**PLANNING COMMISSION REPORT
REGULAR AGENDA -- PUBLIC HEARING ON VARIANCE REQUEST ONLY**

PC Staff Report
12/14/09

ITEM NO. 1B: PRELIMINARY PLAT FOR MERCATO; 29 ACRES; NE CORNER OF K-10 & W 6TH (MKM)

PP-10-05-09: Consider a four lot commercial and residential office Preliminary Plat on approximately 29 acres and variance to permit block length of greater than 800 ft for the Mercato project located at the NE corner of K-10 & West 6th Street (Hwy 40). Submitted by JDS Kansas, L.C.; Kentucky Place, L.C.; Tanglewood, L.C.; Oread, L.C.; Hanover Place, L.C.; Venture Properties, Inc.; TAT Land Holding Company, L.C.; Scotsdale Properties, L.C.; Sojac Land Company, L.C; K-10/40 Development, L.C., property owners of record.

Figure 1. Summary of changes being proposed with PP-10-05-09 overlaid on previously approved plat PP-01-02-06.

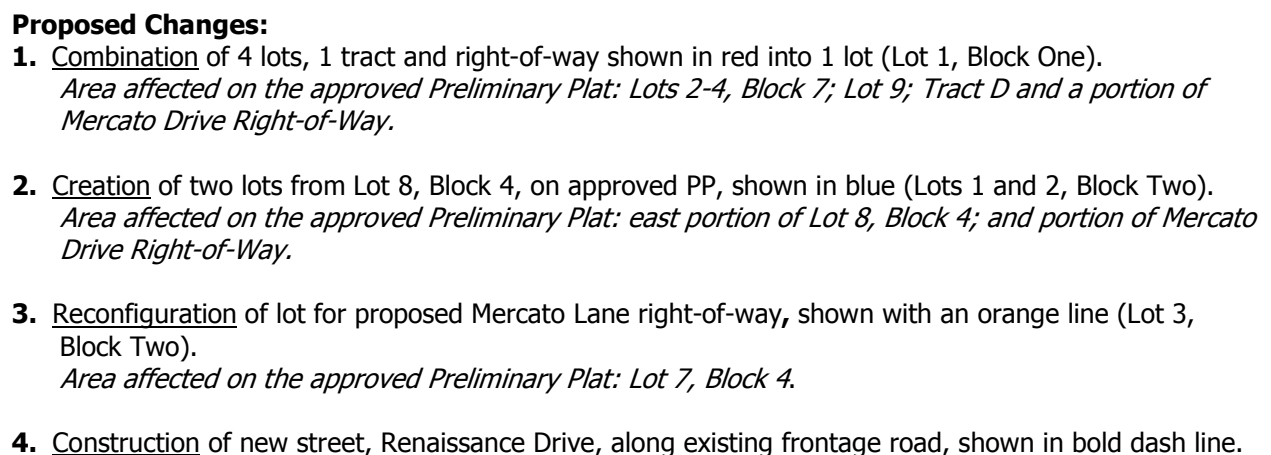
This preliminary plat (PP-10-05-09) proposes to revise a portion of the approved preliminary plat for the Mercato Subdivision. The revised preliminary plat was submitted concurrently with a rezoning request to rezone approximately 24 acres from UR (RMO pending) to the CC400 District. This plat proposes to reconfigure the 4 lots located between the proposed planned commercial development and the K-10 Bypass into one lot. The plat also proposes a right-in / right-out access onto W 6th Street and a reconfiguration of lot lines (Lots 6 and 7 of Block Four of the approved Preliminary Plat) to provide right-of-way for Mercato Lane, the proposed access onto W 6th Street. Figure 1 illustrates the changes which are being proposed with this revised plat.

George Williams Way. Mercato Drive parallels the lots adjacent to George Williams Way and W 6th Street and provided access to these lots, as access to W 6th Street was restricted. The revised plat proposes an access point onto W 6th Street, and the elimination of the portion of Mercato Drive between the commercial and residential-office portions (north/south portion) as this area would now be zoned for commercial use and access would occur internally. Mercato Drive would continue to the west where it would convert to Renaissance Drive and follow the alignment of the present frontage road to the north. These changes are illustrated in Figure 1.

Figure 1. Previously approved preliminary plat (PP-01-02-06)

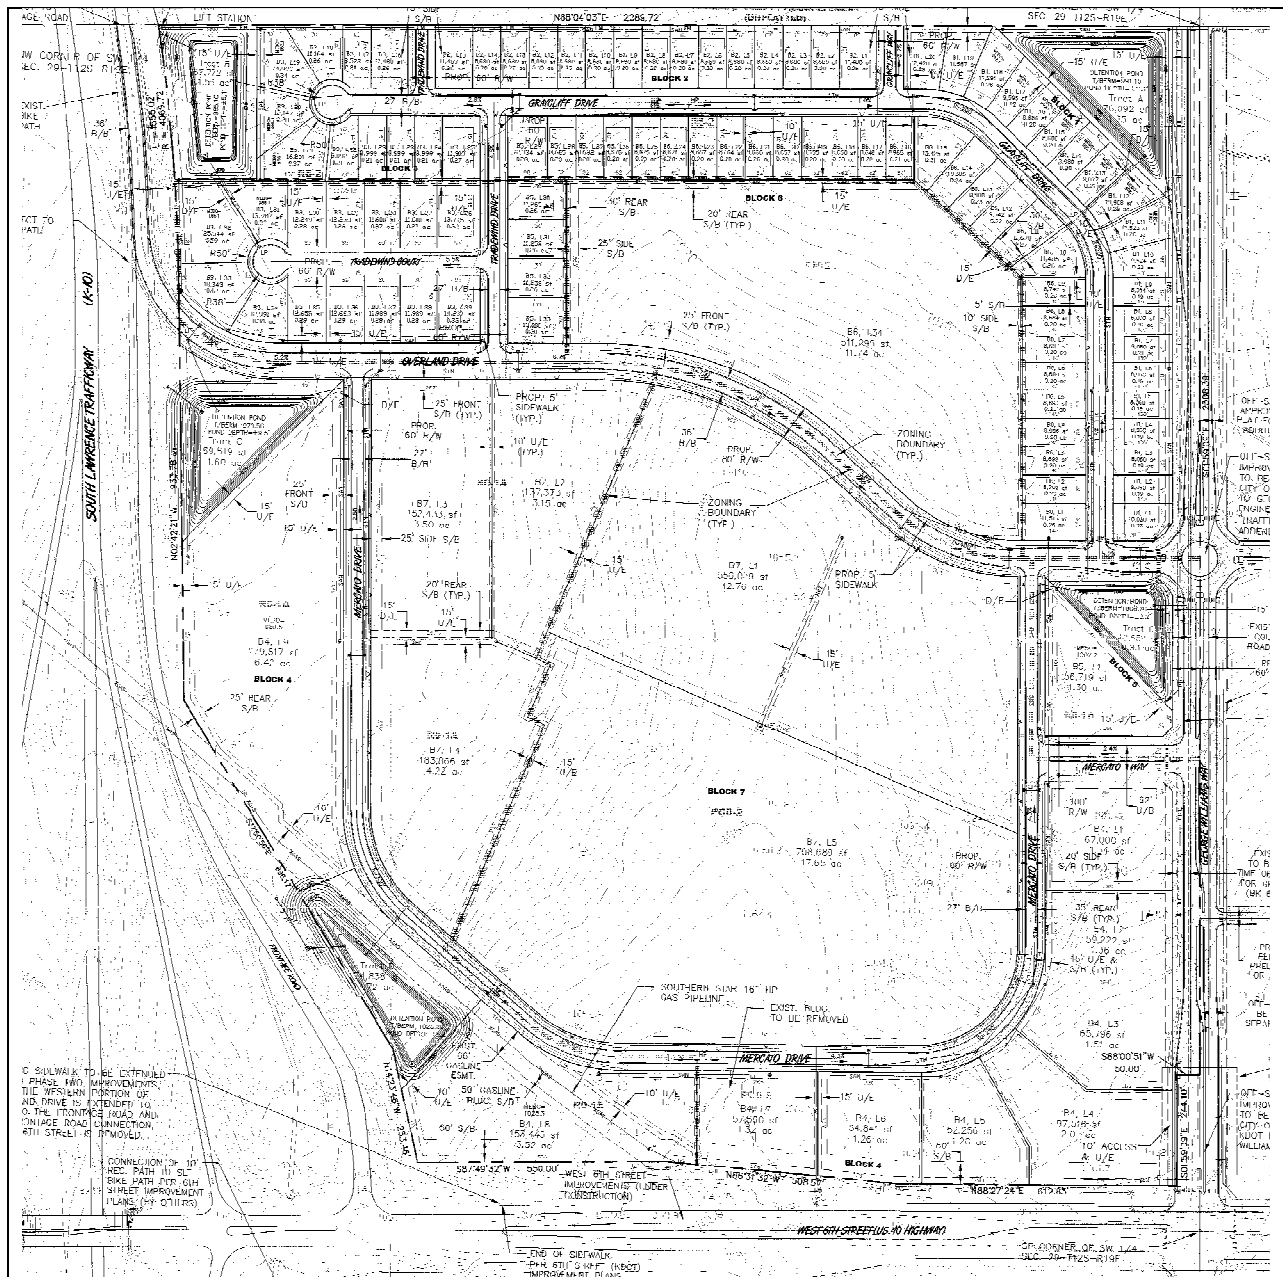
The approved preliminary plat for the Mercato Development, Figure 2, contains an internal drive between the Planned Commercial section of the development and the Residential-Office, Mercato Drive. Access into the site was taken by Mercato Way and Overland Drive off of
